APPLICATION NO: 03/2016/0845/ LB

PROPOSAL: Listed Building Application for replacing existing roof structure on rear conservatory to a glazed roof; re-instate square pyramid roof structure to rear; form new natural slate colour zinc clad roof covering above store to rear and replace guttering and downpipes to Cast Iron

LOCATION: Pen Y Bedw Cottage Birch Hill Llangollen

Existing Plan
 DRG No: 1605-01 / B
 05/09/2016
 Scale 1-100 @ A3

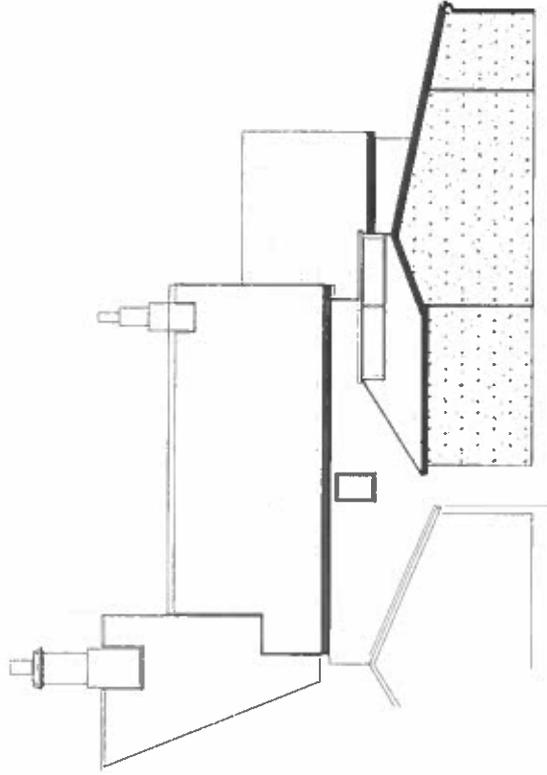
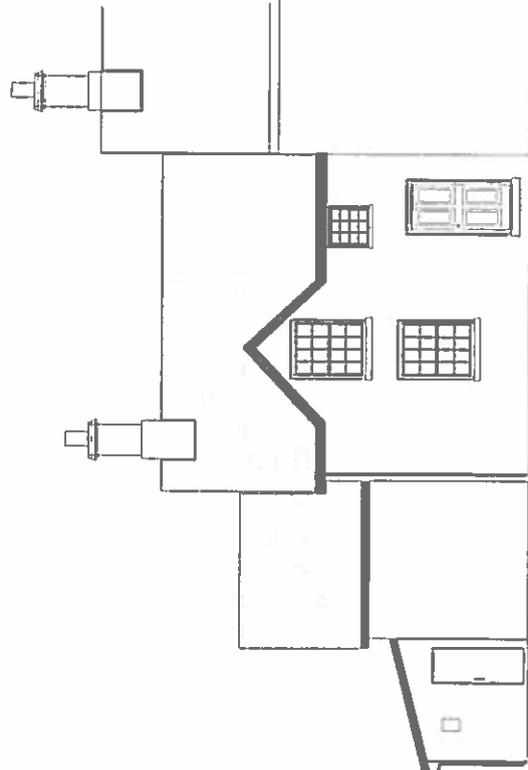
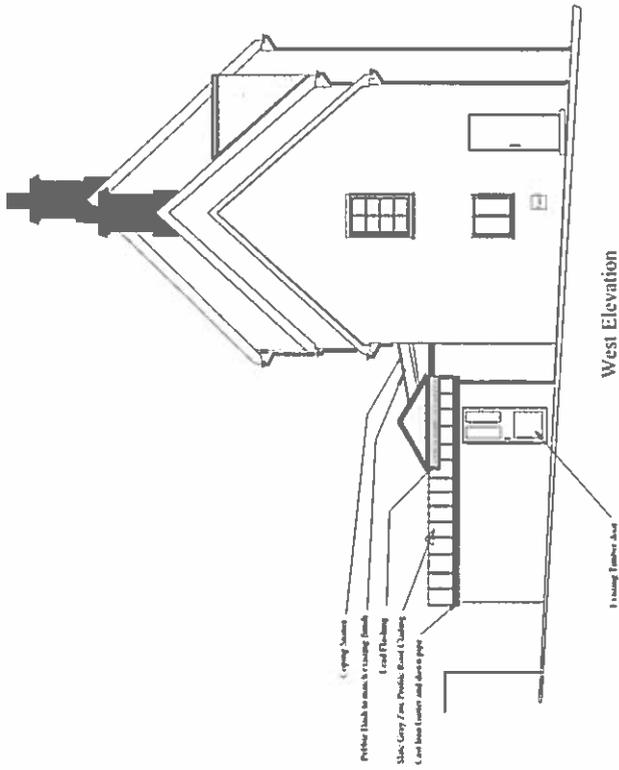
The current application is lacking in detail and the existing plans are inaccurate and do not correctly show the rear wing. In addition to this, insufficient evidence of the historic layout, development of the site over time, significance and justification for the alterations has been provided in order to fully assess the application.

Proposed Plan
 DRG No: 1607-03 / B
 05/09/2016
 Scale 1-100 @ A3

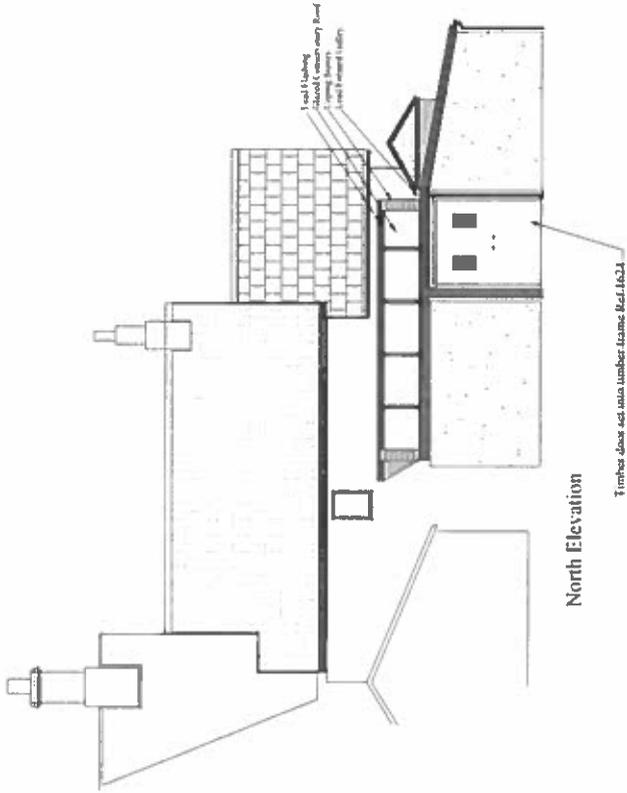
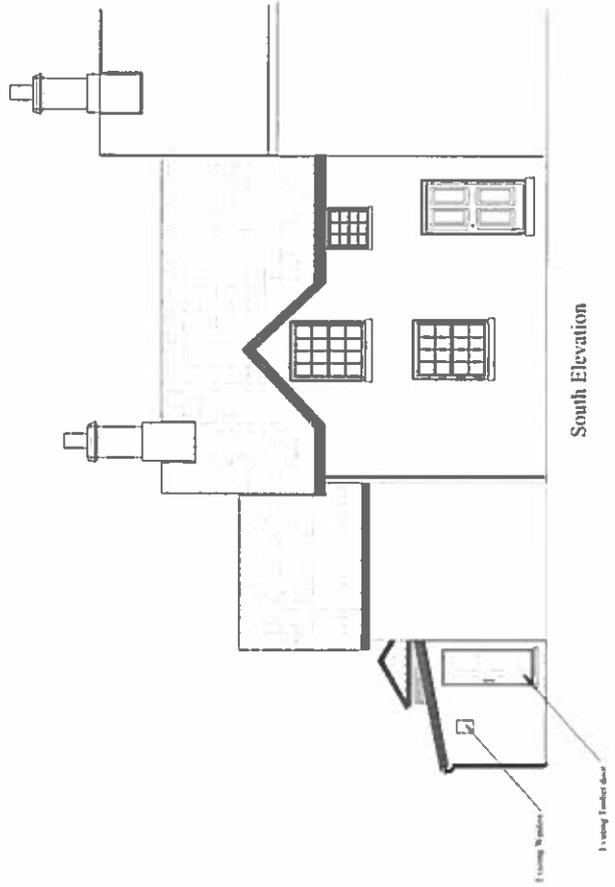
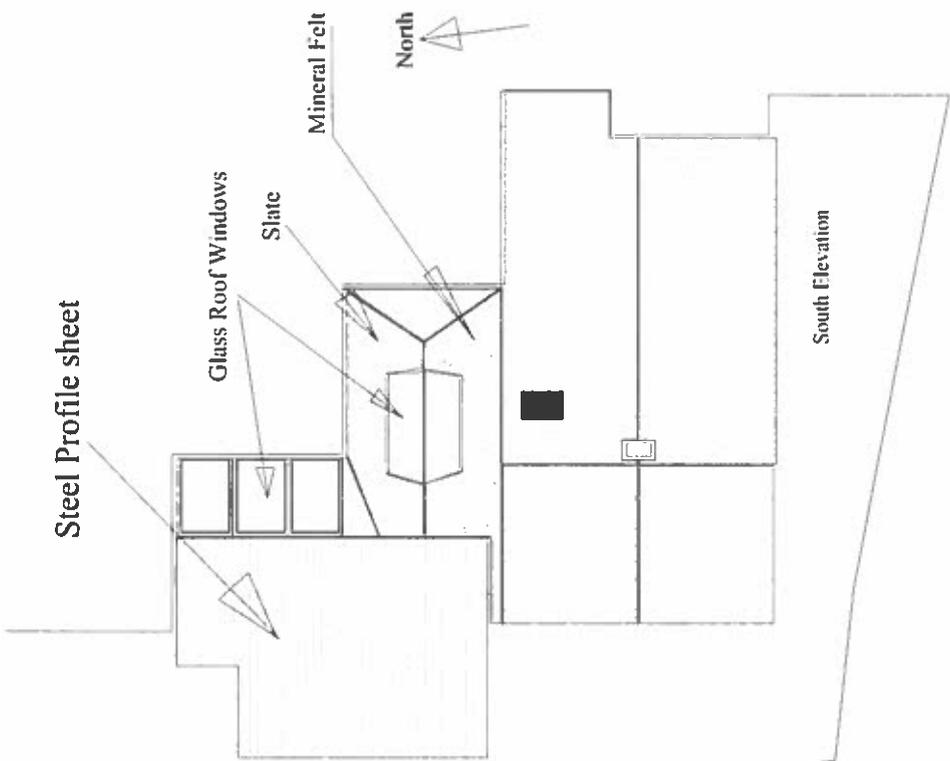
It was therefore resolved to object to the application on the following grounds. Whilst the reinstatement of the pyramid roof feature and potential improvement to the rear of the site are welcomed, there are concerns over the proposed alterations to this listed building. Any new extension to the rear should be subservient to the pyramid roof and be mindful of the character of this vernacular cottage. The height, design and materials proposed do not meet these requirements. The proposed new conservatory is higher than the pyramid roof but should be lower, and the proposed use of coping stones does not reflect the style and features of the cottage. The double doors and amount of roof glazing introduce completely modern and inappropriate features to the rear of the property, and when combined with the increased size of the conservatory completely alter the rear elevation of the property, creating a visual intrusion, dominating the rear elevation and changing the look of it from a vernacular cottage to a modern building as well as taking the eye away from the original building, whereas the smaller scale outbuildings currently in situ do not do this.

Whilst part of the roof is tin sheeting, this does not mean that it is appropriate to replace it with a modern metal roofing material. If the tin sheeting is to be replaced, then it should be replaced with slate to match the rest of the building. Using a modern material such as zinc is not appropriate on a listed building and will take the eye away from the key feature of the pyramid roof.

“I believe the proposals are acceptable for this listed building as the original pyramid and sheeted roofed buildings to the side which are visible from public highway are being maintained in their original form. The pyramid roof is being roofed in slate and the sheeted section of roof having a zinc replacement. Zinc is an acceptable material to be used on a listed building to replace the metal sheeting as a slate roof is not possible in this situation as the pitch is too shallow for slate.

The proposed conservatory is acceptable in my opinion as it is on the rear elevation not visible from the public highway and the glazing will be screened to both side elevations by parapet walls. This building will be replacing a very poor previous extension of little architectural merit. Again as the roof pitch is below the recommended pitch for slate therefore an alternative material is required in this situation and it will have a timber roof structure to support the glazing.”

In respecting the views expressed by the Town Council, it is considered that the proposed alterations are actually positive in addressing unauthorised and inappropriate previous alterations. The use of materials such as zinc on historic buildings can add an interesting contrast with more traditional materials on listed buildings. Further, the list description makes it clear that Pen Y Bedw has already been altered in a modern way, and so it is reasoned that this proposal, in line with circular 61/96, would preserve the existing character of the building, and not harm it.

Significantly, in this case, It is not considered that the proposal would unacceptably affect the historic character of the building – the main element of which is the front façade and group value with Pen Y Bedw, Highcroft, Birch Villa, Croes y Beddau and Llwyn Aeron. It is suggested that the reinstatement of the pyramidal roof would enhance the character of the building, and the conservatory section, given other
